Historic Architectural Review Commission Staff Report for Item 9

To:	Chairman Haven Burkee and Historic Architectural Review Commission Members
From:	Enid Torregrosa-Silva, MSHP
	Historic Preservation Planner
Meeting Date:	November 18, 2024
Applicant:	Douglas Pat Burdette, Contractor
Application Number:	H2024-0051
Address:	408 United Street

Elevate home and rear porch from 4.97' to 9.06', new steps, and new foundations.

PROPOSED STAIR DETAILS 2 NEW WOOD STAIR AT RAISED HOME

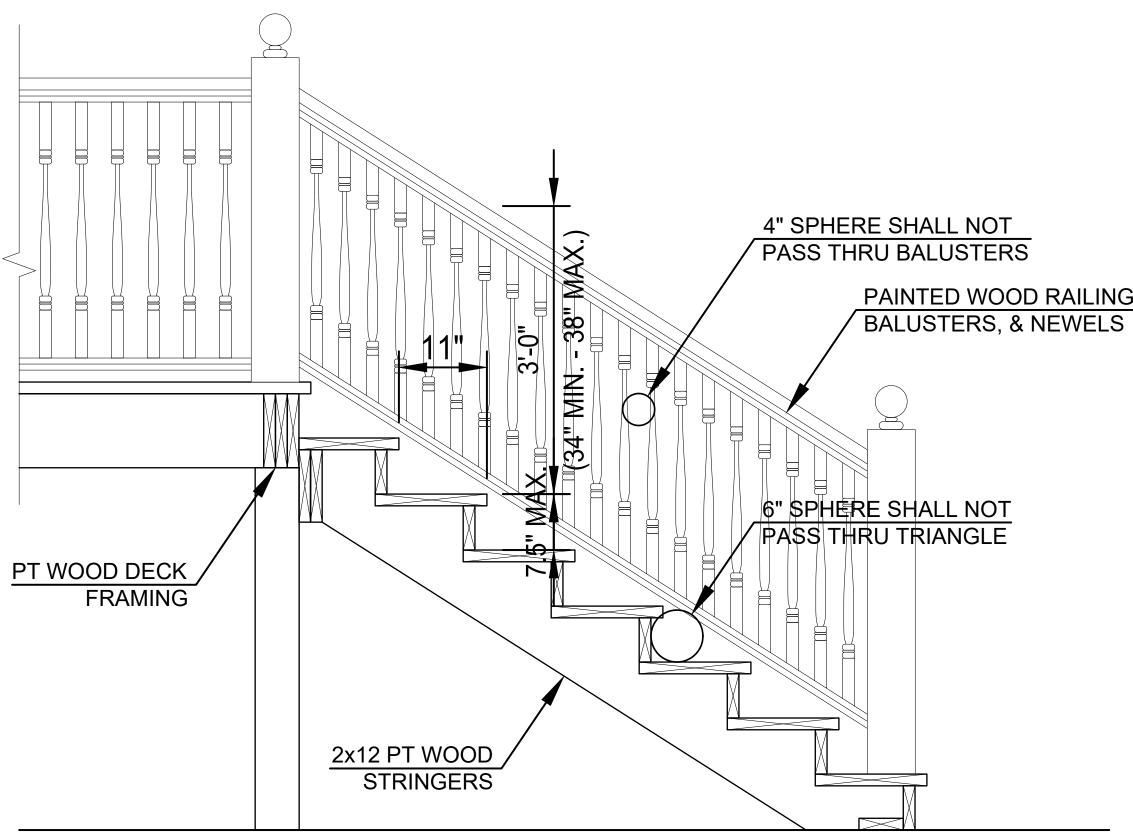
The revised plans include notes as to "existing porch to be demolished and removed" on existing conditions and "rebuild demolished porch after elevation is complete" on proposed floorplans and elevations. Proposed elevations also still not include the spiral staircase. Front and visible railings from street should be wood.

Also, I am seen a detail of railings with tubular balustrade, handrail, and bottom rail. This house must have wooden railings and balustrades, due to its age. There is no annotation of materials for the lattice, for which the Commission requires it to be wood.

- The proposed front steps will be wooden steps.
 - 4. Lattice work infill between new concrete footers will be wood.
- The latticework infill will also be wood.

Front porch demo is the non-structural concrete slab only. We will carry the porch posts and baluster railings up with the house. We can eliminate the stair railing or change it as needed. Wood lattice is intended and can be called out if needed.
